STAFF'S
REQUEST ANALYSIS
AND
RECOMMENDATION

00PR0149

Laverne C. Cole
(Cole C'Store)

REQUEST: Site Plan Approval.

C-STORE
BERNARD DISTRICT - CHESTERFIELD COUNTY, VIRGINIA
LANDSCAPE PLAN

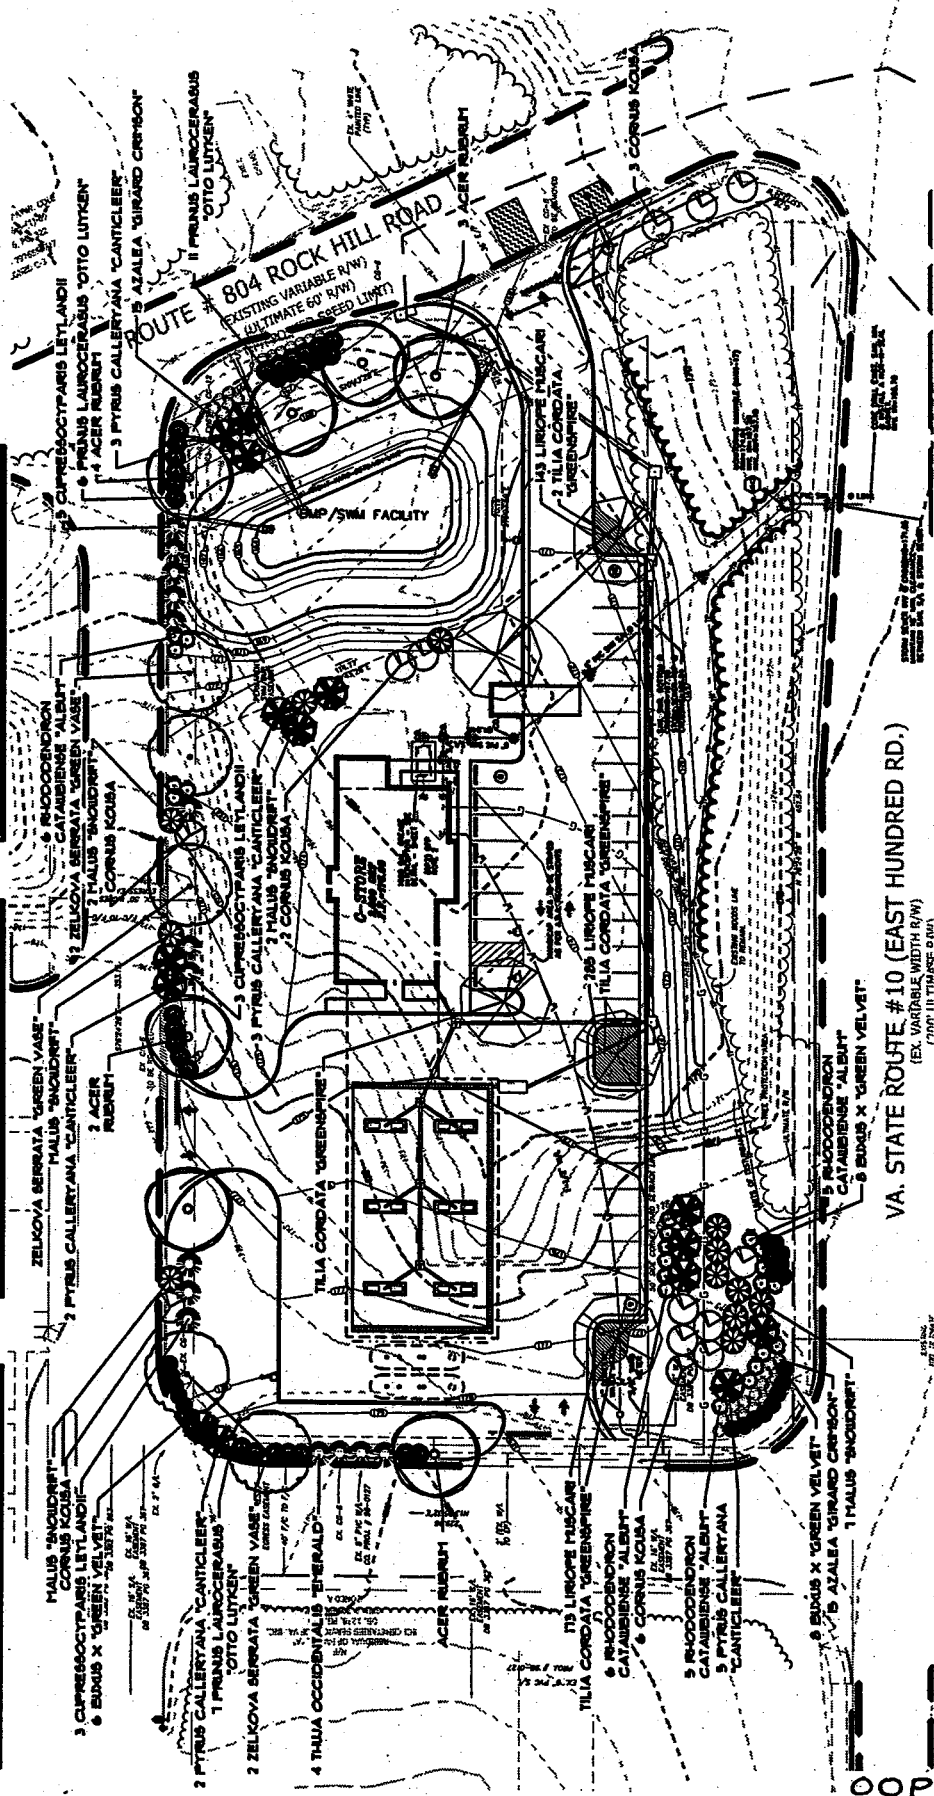
12. Per previous comment 4, revise the grading and storm water sewer as needed to retain all trees within the front yard setback and the corner side yard setback. This may require a retaining wall and a relocation of parking to allow this wall to be located outside of the setback. (P)

13. Per previous comment 6, relocate the sanitary sewer out of the tree save area. For this site you may locate the sanitary sewer 30 feet or more from existing trees. (P)

14. Per previous comment 10, relocate the electric service line outside of the tree save area. For this site you may locate the electric service 30 feet or more from existing trees. (P)
